CONNECTICUT SITING COUNCIL

RE: **PETITION NO. 1058** - The Connecticut Light and Power Company Declaratory Ruling that no Certificate of Environmental Compatibility and Public Need is required for the proposed 1990 line structure replacement project consisting of modifications of two sections of an existing 115-kV transmission line from Stevenson Substation to Frost Bridge Substation and from Baldwin Junction to Baldwin Substation traversing the municipalities of Monroe, Oxford, Middlebury, Waterbury and Watertown, Connecticut.

Re: **PETITION NO. 1058** - The Connecticut Light and Power Company petition for a declaratory ruling that no Certificate of Environmental Compatibility and Public Need is required for the proposed 1990 line structure replacement project consisting of modifications of two sections of an existing 115-kV transmission line from Stevenson Substation to Frost Bridge Substation and from Baldwin Junction to Baldwin Substation traversing the municipalities of Monroe, Oxford, Middlebury, Waterbury and Watertown, Connecticut – Request to modify the approved landscaping plan at Shaw's Hill Substation in Watertown.

PLANTING PLAN
SHAW'S HILL 24H SUBSTATION
428 SUNNYSI

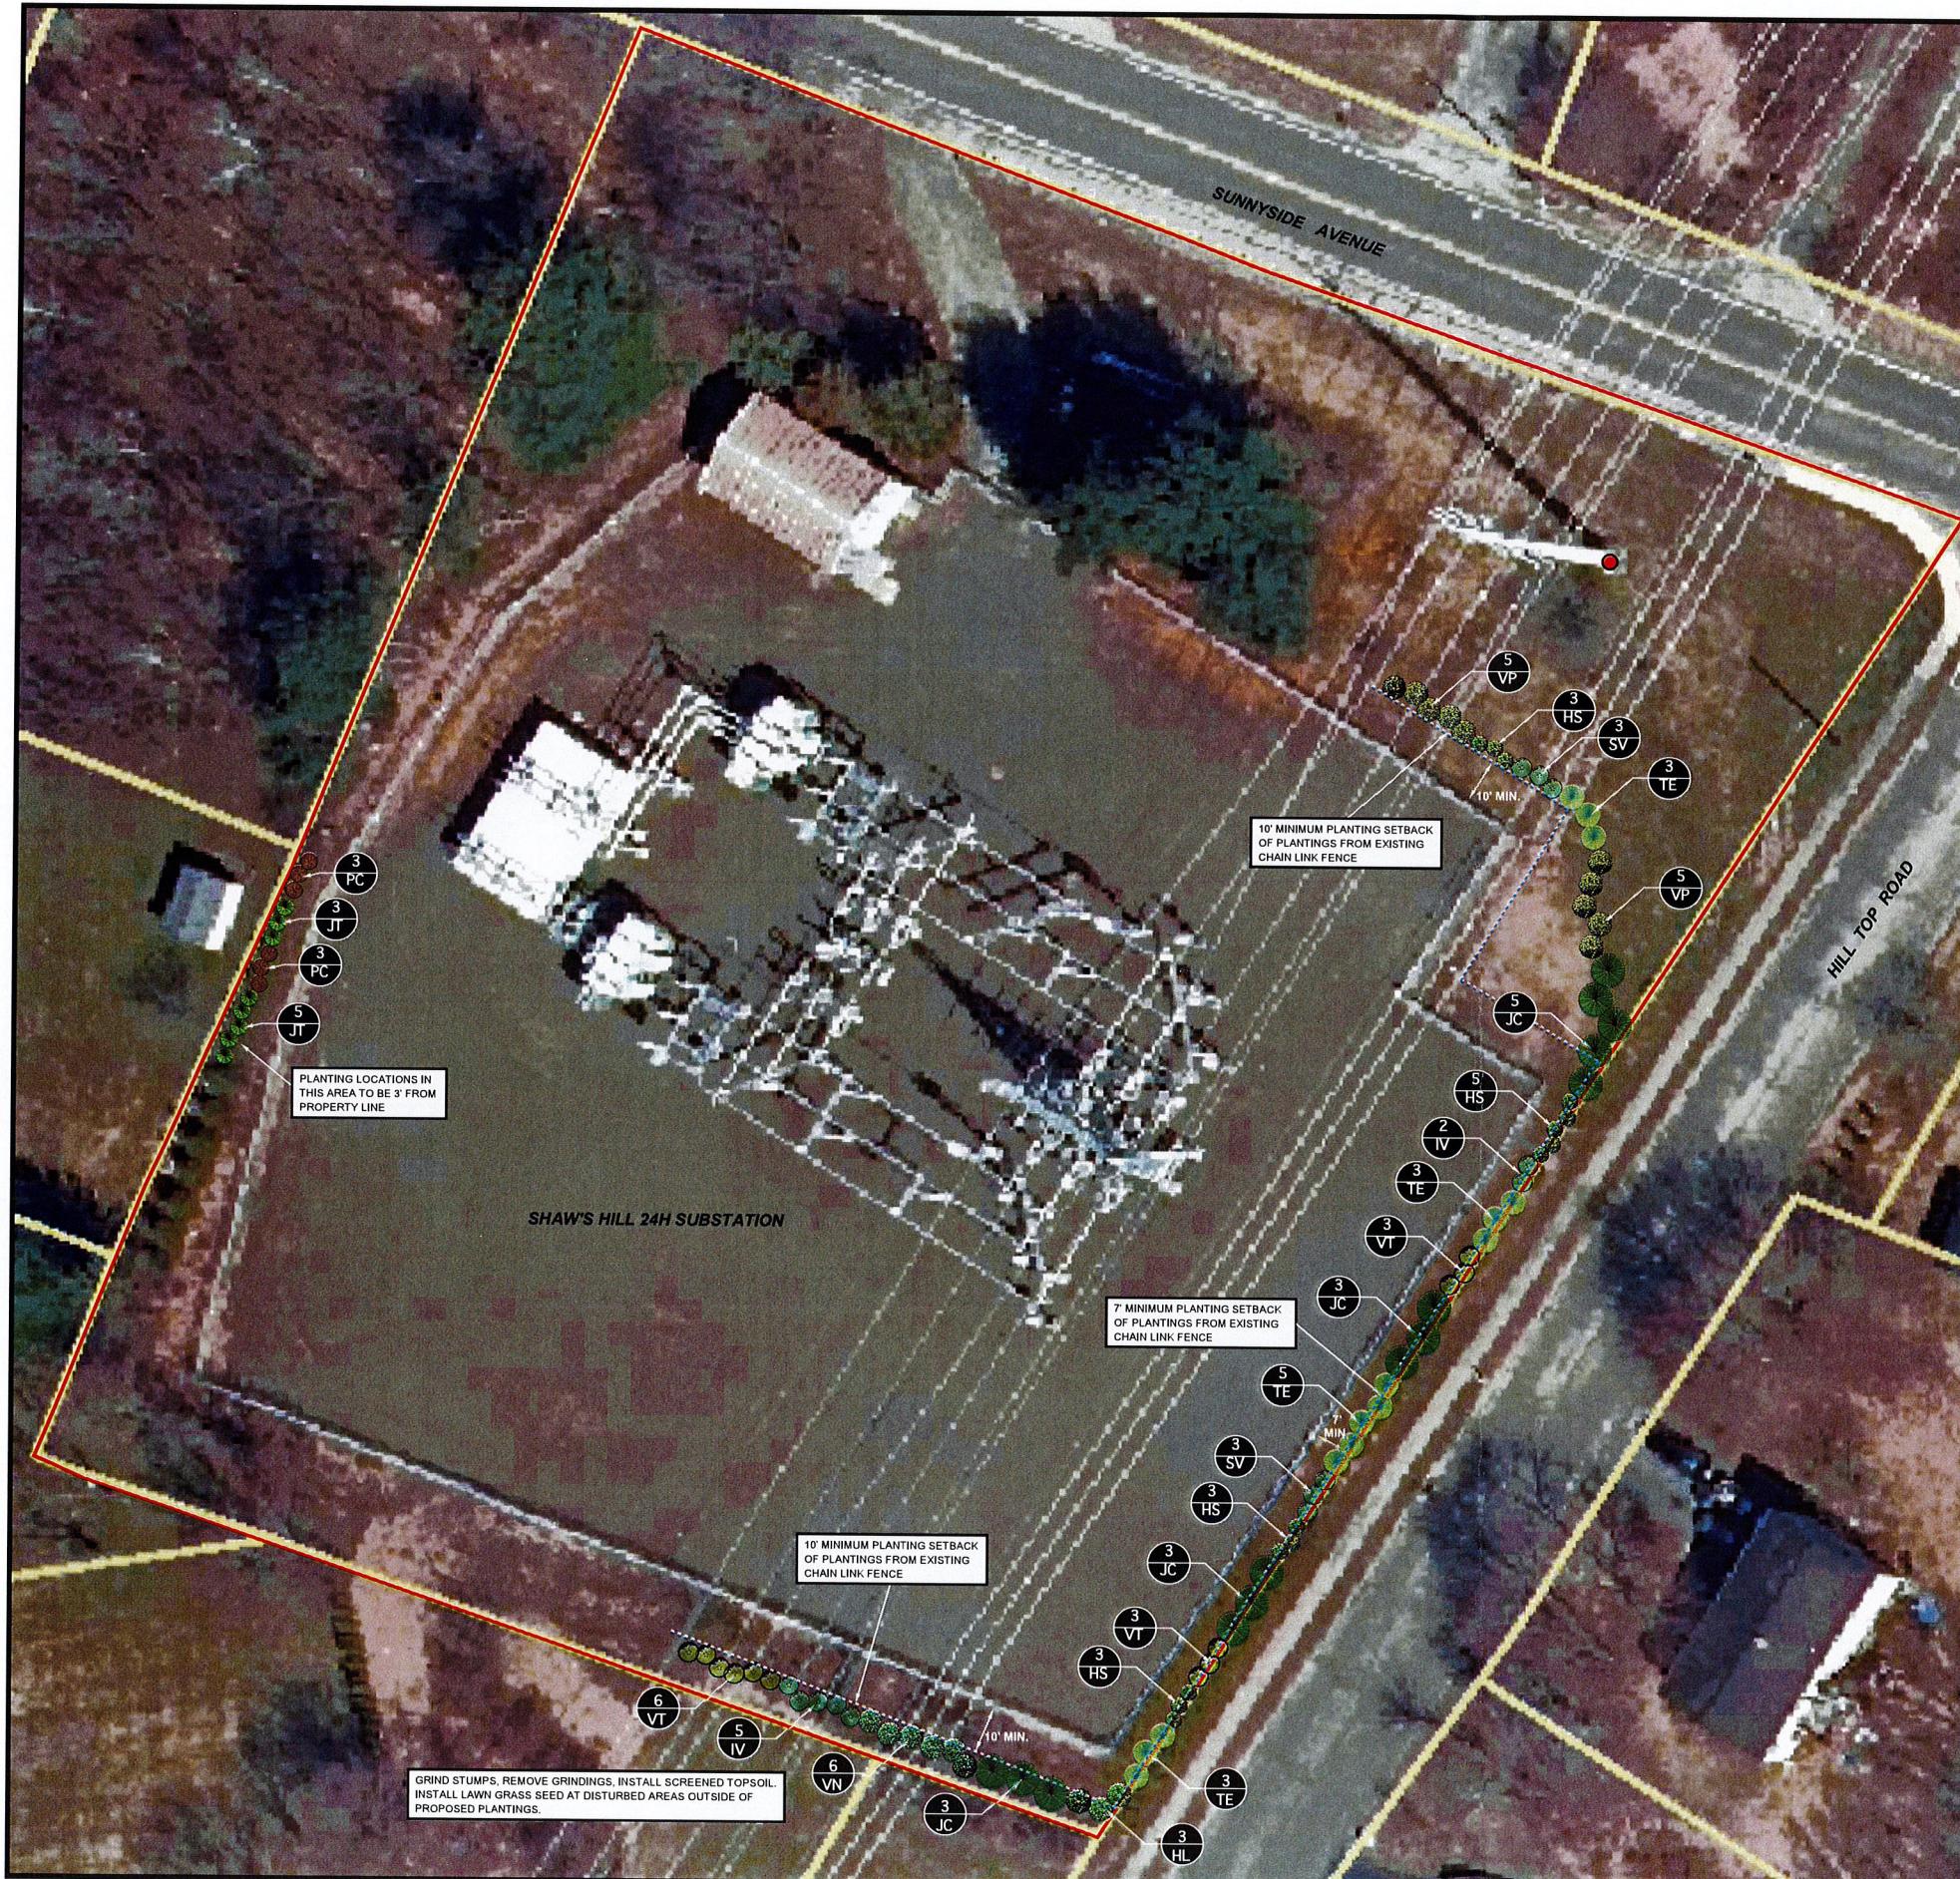
Since that time, Eversource has upgraded its vegetation standards and is currently working to remove “non-compatible” species. That is, species with the potential to intrude within the wire zone. Eversource's Vegetation Management has reviewed the growth at Shaw's Hill Substation and determined that modifications are required to the current landscape design to mitigate this risk. As a result, Eversource proposes the attached modified landscaping plan for Shaw's Hill Substation.

Pursuant to Regulations of Connecticut State Agencies §16-50j-62(b), your request to modify the current landscape design at Shaw's Hill Substation to mitigate risk, consistent with Eversource's upgraded vegetation standards, is hereby approved.
